job BACTON LOW RISE LONDON NWS	drawn: RR	date: 01.16
drawing TYPICAL BLOCK C DETAILS External wall junctions - RC133 to RC136	scale: 1:10 @ A1 1:20 @ A3	job no: 1952
note: all dimensions to be checked on site at commencement of the work. If this drawing exceeds the quantities in any bill of materials, the contractor is to be informed before the work is commenced. For all other applications from planning application purposes do not scale, use dimensions, this drawing is for information only.	drawing no. D-J-RC133 to D-J-RC136	rev. as below

<i>Rydon</i>		
Received	Initial	Date
RYDON	RA	25 Jan 16
Client		
Status A - No Comments		<input type="checkbox"/>
Status B - Comments, Revise & Resubmit		<input checked="" type="checkbox"/>
Status C - Rejected		<input type="checkbox"/>
For Information Only		<input type="checkbox"/>

DETAIL - Block C - D-J-RC133 - Structural Post Encapsulation WT-RC1 (L03 to 07 GL E-09)

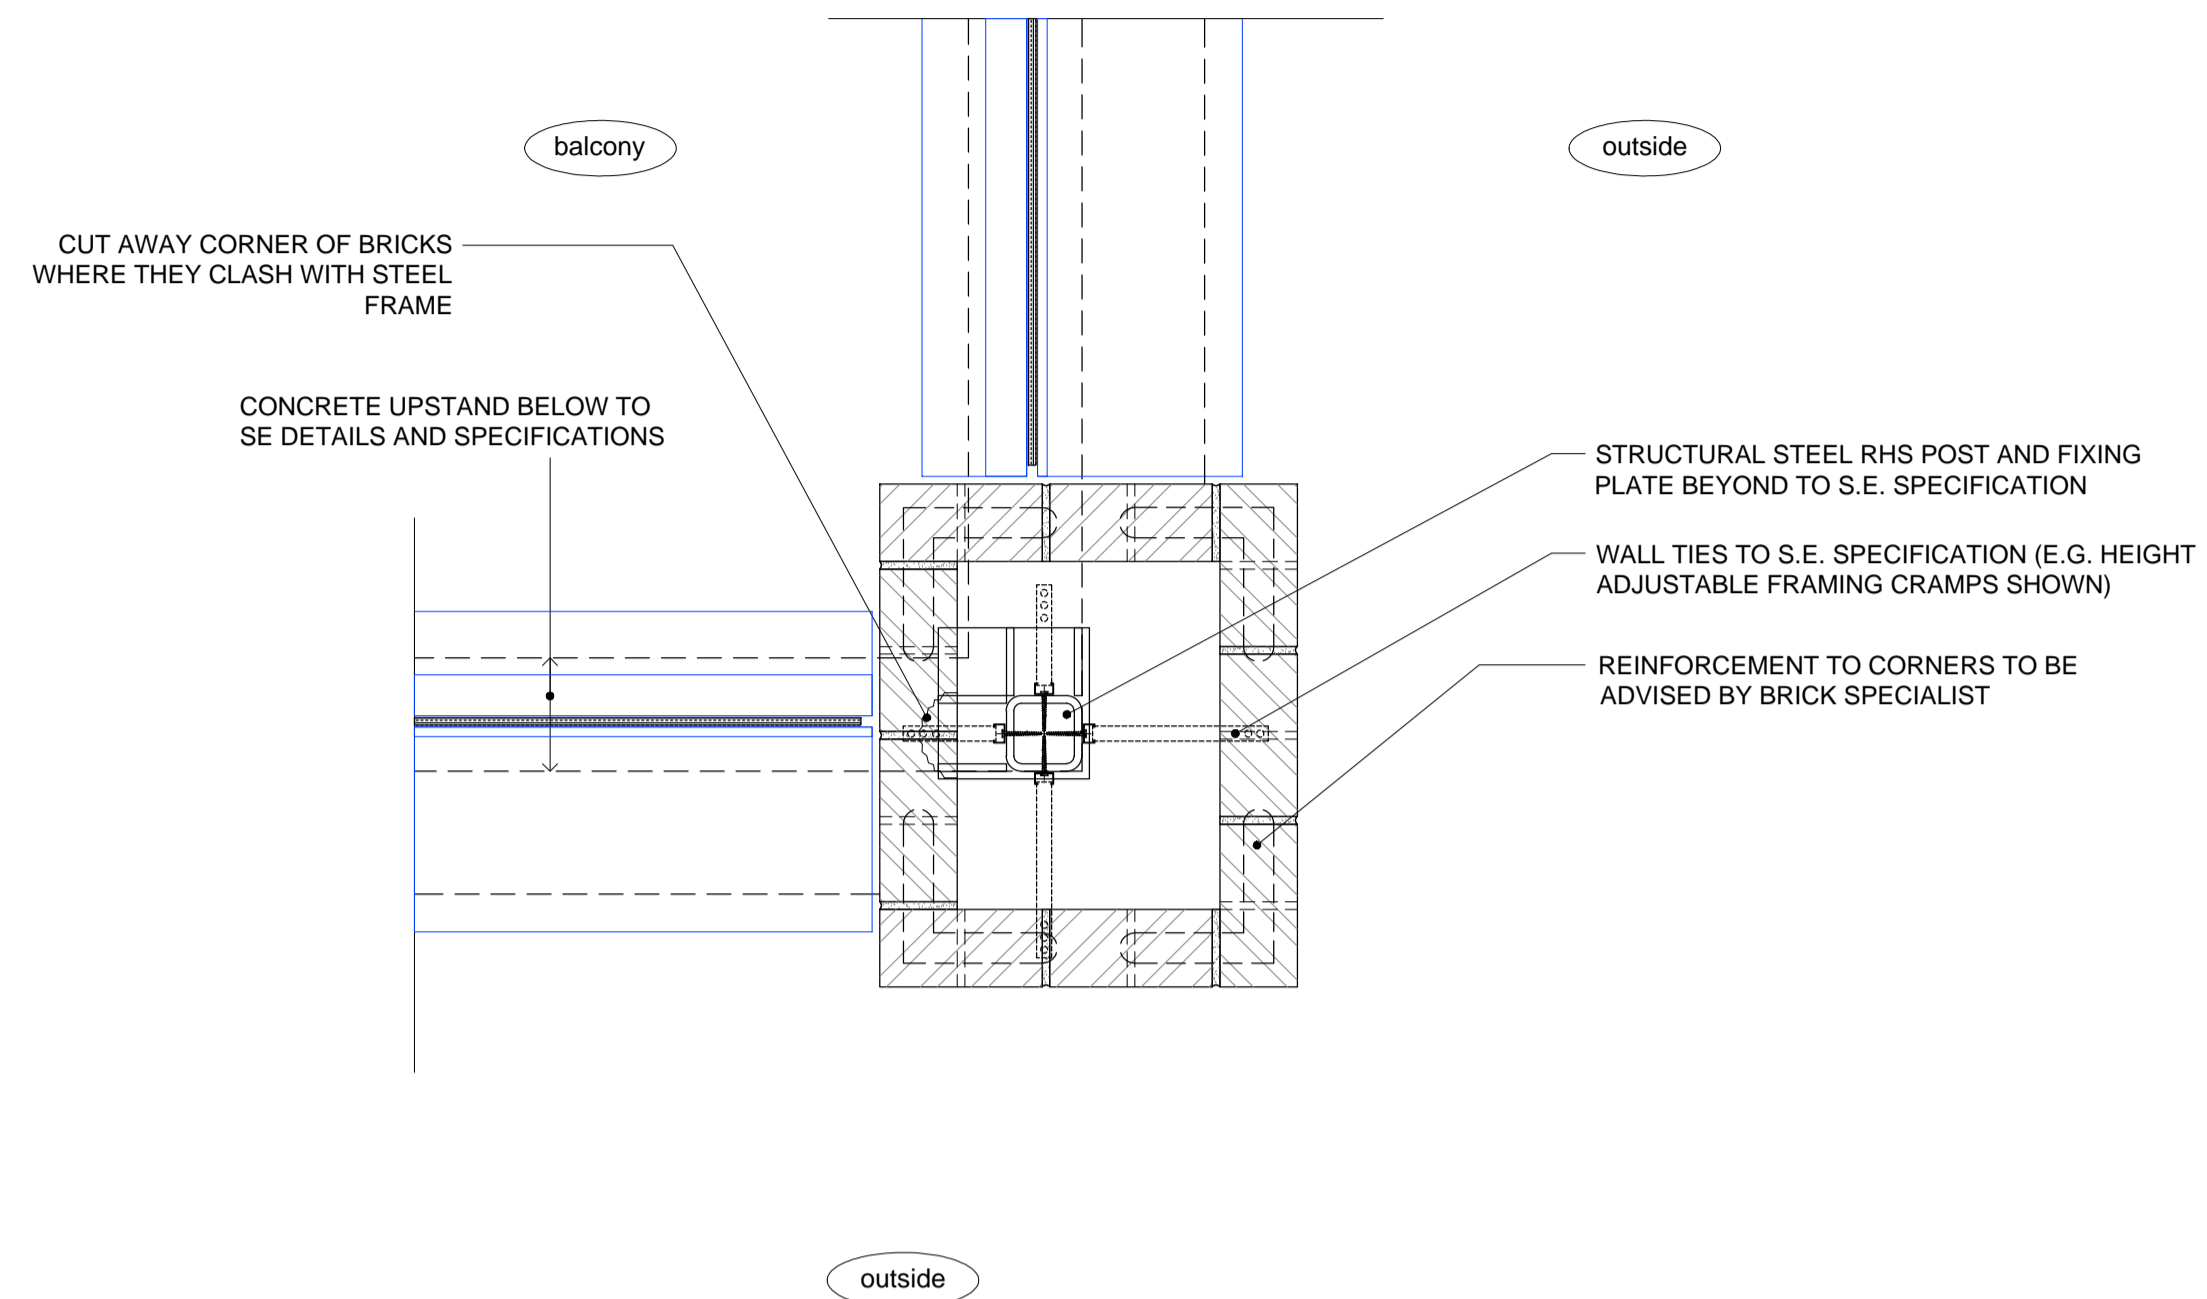
Will this present a trip hazard on the terrace?
See also comments on D-J-RC-129-132.
